## Letter 29. Individual (Jon Spangler)

# Comment Letter 30

**Traffic Volume Summary at Island Gateways for Existing and Cumulative Peak Hour Conditions without and with Project**

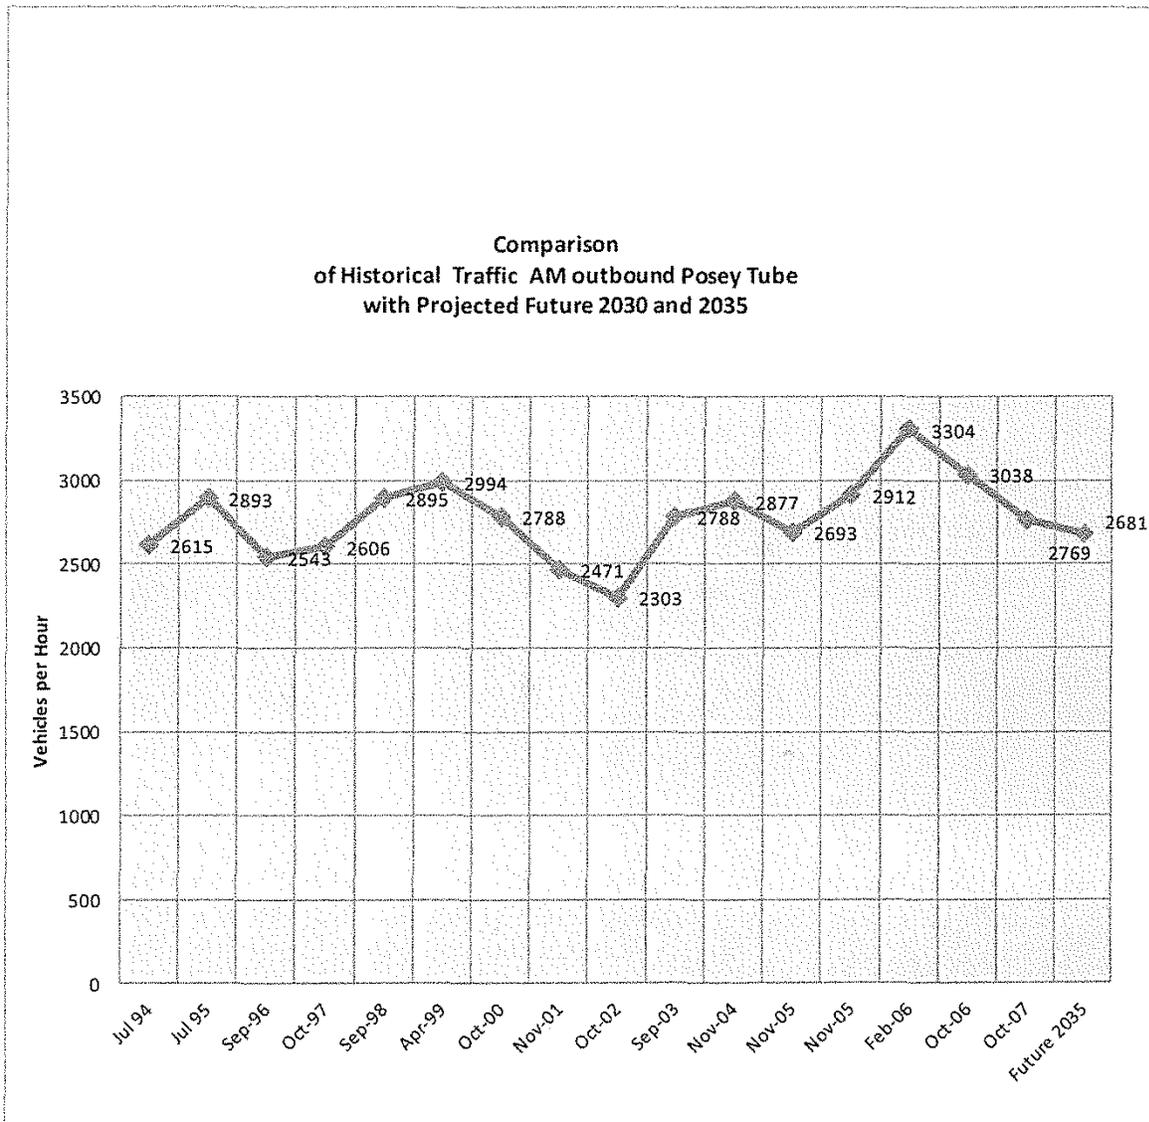
Specifically, the Traffic Impact Analysis in the DEIR concludes the project increase would only be 1 (one) additional vehicle per hour for outbound traffic into the Posey Tube during the AM peak hour if project were built today (see existing plus project as per Appendix G of the DEIR). And a mere 1 (one) vehicle per hour, due to the project at the all estuary crossings, for the cumulative plus project (year 2035) condition and traffic volumes dropping with the project at some of the island crossings. See below.

Source: Historical volumes as per Capacity Management Memo to City Council, by Matt Naclerio, past Public Works Director, October 1<sup>st</sup>, 2008. Caltrans counts show similar historical counts. The 2035 Forecast was provided in the Appendix G of the Alameda Point DEIR for Cumulative (2035) plus project condition. (see the northbound approach at the 7<sup>th</sup> and Harrison Intersection, intersection number 38 Figure G- 8C in Appendix G of the DEIR.)

- 30-7 The comment is incorrect. The Draft EIR did not "conclude" that the project would result in one (1) single trip in the tubes. The Draft EIR concluded that the proposed project would generate a variety of significant unavoidable impacts (see Chapter 2, *Executive Summary*, provides a convenient and easy to understand summary of the impacts). As documented in the Final EIR for the Alameda Point General Plan Amendment in 2003, the Alameda Landing Supplemental EIR in 2006, and a variety of other City of Alameda traffic studies over the last 10 years, the capacity of the Webster and Posey Tubes is a fixed to a specific number of automobiles that can cross between the two cities during the

- AM or PM peak commute periods. The City of Alameda conducts an annual count of automobiles using the tubes in the AM and PM period and reports those counts annually. It is well documented that the existing tubes have been at or near capacity for the last six to seven years. Therefore, the Draft EIR found that regional growth and other development that is planned in Alameda over the next 20 to 30 years will exceed the capacity of the Webster and Posey Tubes. The Draft EIR finds that limited capacity of the tube causes many automobile trips to divert to other crossings during the AM and PM peak period. It should also be expected that the peak hours of congestion will “spread” as more commuters choose to leave earlier or delay their commute to later in the morning to avoid the peak hours of congestion. Also see response to Comment 17-5.

- 30-8 As shown in the figure, historical traffic counts range between a low of 2,300 to a high of 3,304. Recent counts from 2012 for the Posey tubes in the AM range from 2,368 to 2,888 for the mid-week (Tuesday through Thursday) workday. These volumes for the AM peak hour are fairly consistent despite the changes in activity at Alameda Point since its height of activity as the naval air station. See response to Comment 17-6.

The following graphic included in my June 24<sup>th</sup>, 2013 letter, illustrate the no impacts from the 09 GPA DEIR

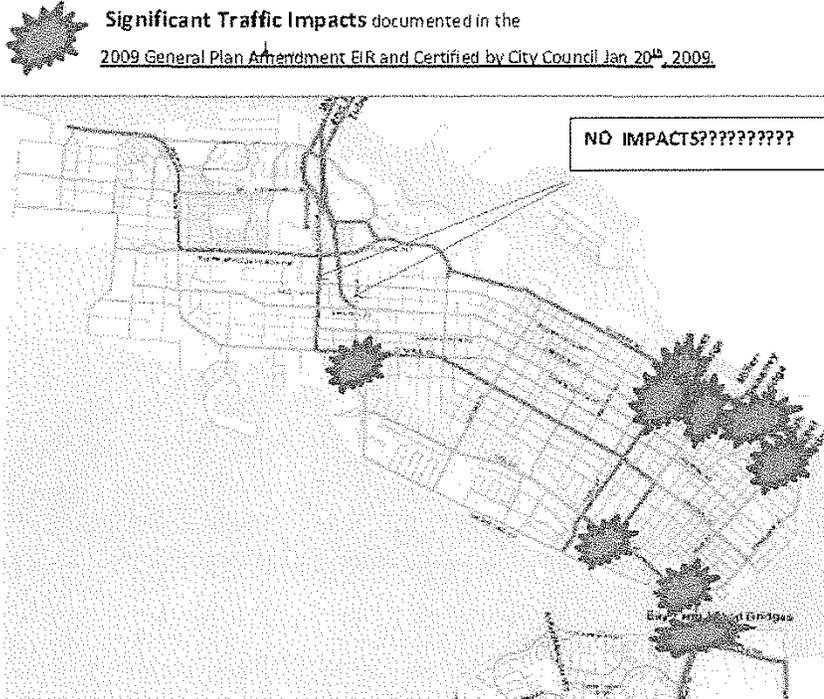
At a minimum the City should review the traffic model used in the DEIR and fully explain why the delay at the west end concluded in the Traffic Model has been eliminated in this DEIR and other previous reports.
